Call owner
City of Portland, Maine – Building or Use Permit Application 389 Congress Street, 04101, Tel: (207) 874-8703, FAX: 874-8716

Proposed Project Description: Remove existing deck Construct sunporch & deck		PEDESTRIAN ACTIVITIES DISTRICT (P.U.D.) Action: <input type="checkbox"/> Approved <input type="checkbox"/> Approved with Conditions <input type="checkbox"/> Denied		Signature: _____ Date: _____ Signature: _____ Date: _____
Permit Taken By: Mary Gralkk	Date Applied For: 27 July 1995

BUILDING PERMIT REPORT

CHECK LIST AGAINST ZONING ORDINANCE

31 ELIZABETH ST.
PEAKS ISLAND, ME

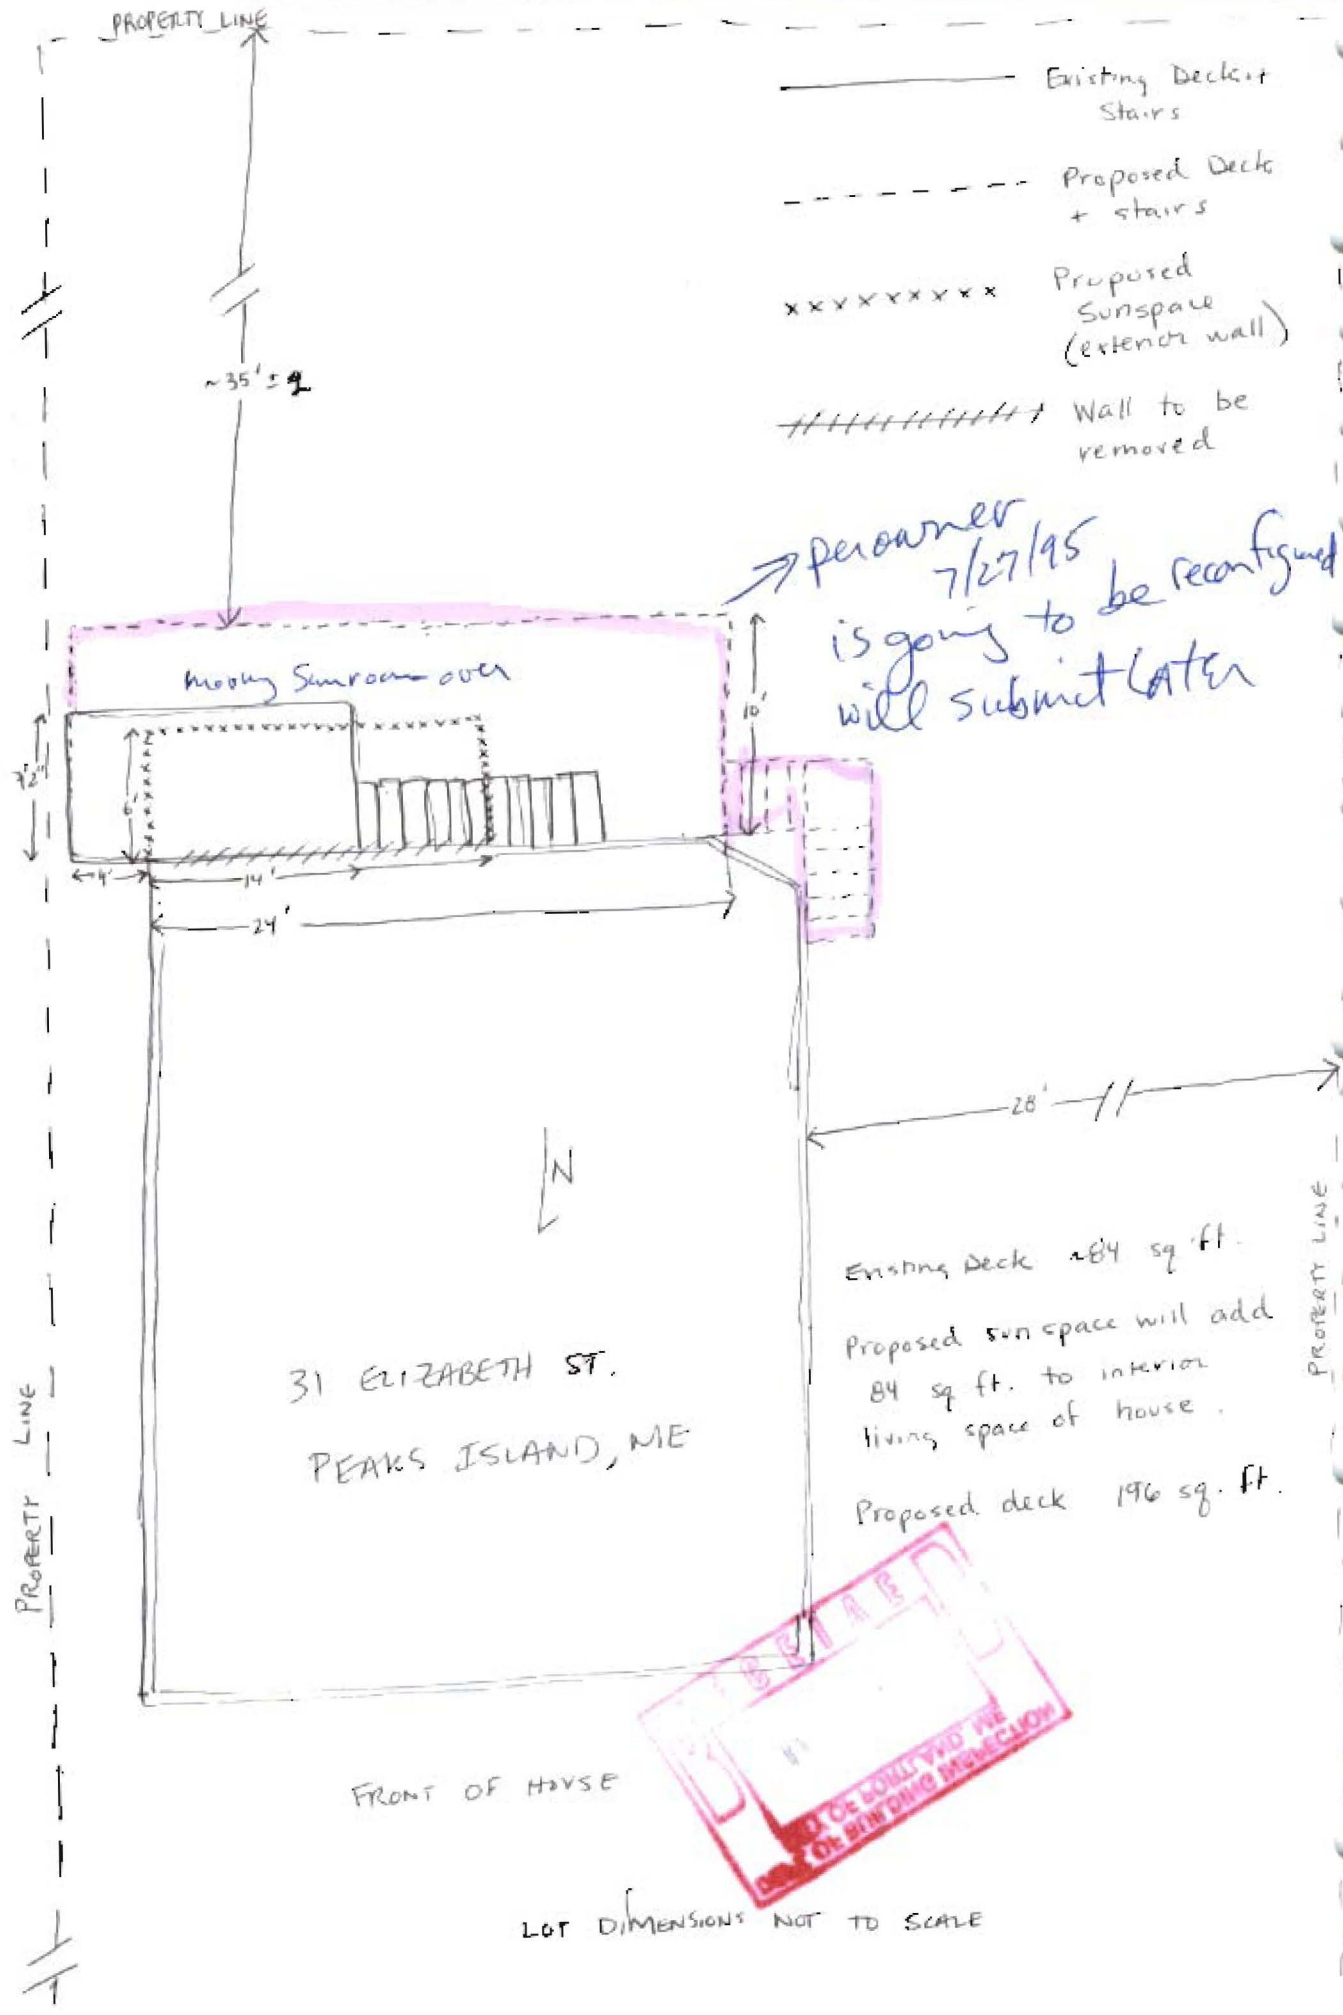
owner 7/27/95 is going to be reconfigured will submit later

moving Sunroom over

Side Yards - moving over existing deck 4' to make a sunroom - same square footage
normally 20' req making the set back less nonconforming

condition - The attached deck ^{shown on plans} is to be reconfigured later, but per owners telephone conversation it is not included in this permit.

20: Per phone conversation the proposed new decks will NOT be built. This permit is for sunroom only.
